Client's Name	Dolores and Stephen Pinkerton
Job Title	33 West Front Road, Pagham

Drawing Title	Comparison of north elevation
Scale	1:125 @ A3
metres	1 2 3 4 5

Drawn	Checked	Date
DH	AD	17.08.26
Job No	Drawing No	Rev
2502	SK04	A
Status	PRELIMINARY

2. Proposal as drawn in granted scheme (1:125)

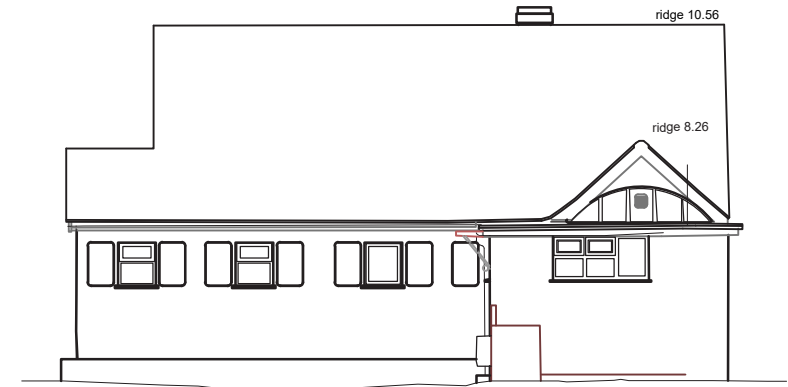
No levels on the proposal.

4. New application to be submitted as Removal/Variation of Condition application (1:125)

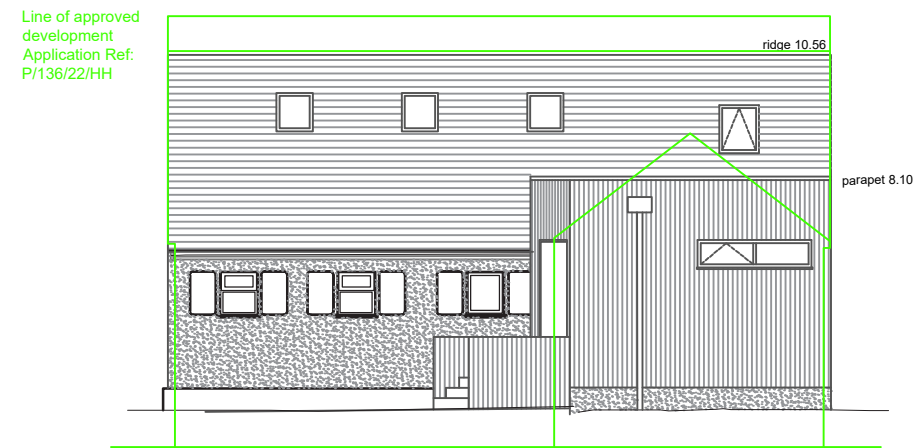
The front extension is higher at the eaves, but the roof height allows us to retain and restore the train carriage internally. Our proposal also shows new steps into the house, unlike the granted scheme that has not shown how people access the higher front door - shown on the east elevation.
